MECKLENBURG COUNTY

MEMORANDUM

RE: Rezoning Petition #2010-55 (Long Creek Greenway)
Charter Properties (PID #025-113-22 and 025-113-05)

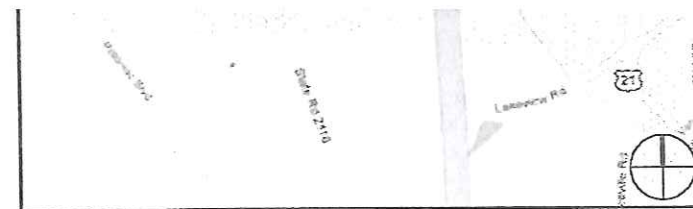
MCPR requests that, although the rezoning involves only a cell tower addition, the petitioner consider possibilities for incorporating public greenway easements connecting interior public roads to the County property at Long Creek. I am available to work with the petitioner to allow the future greenway easement(s) to best serve their development. I have had no contact from the petitioner.

In addition, MCPR requests one small area for additional dedication to the greenway as shown on the attached sketch. Access to Reames Road at the Secretariat Drive intersection is needed for safety and for transportation connectivity.

MCPR REQUESTS ADDITIONAL DEDICATION AT INTERSECTION. SAFETY & TRANSPORTATION ISSUES. MUST ALLOW GREENWAY USERS TO EXIT DUE TO FLOODING AND NEED TO ACCESS REDNES ROAD.

MCPR REQUESTS AT LEAST 1 ACCESS POINT. RECOMMEND THAT THE DEVELOPER PROVIDE MORE.
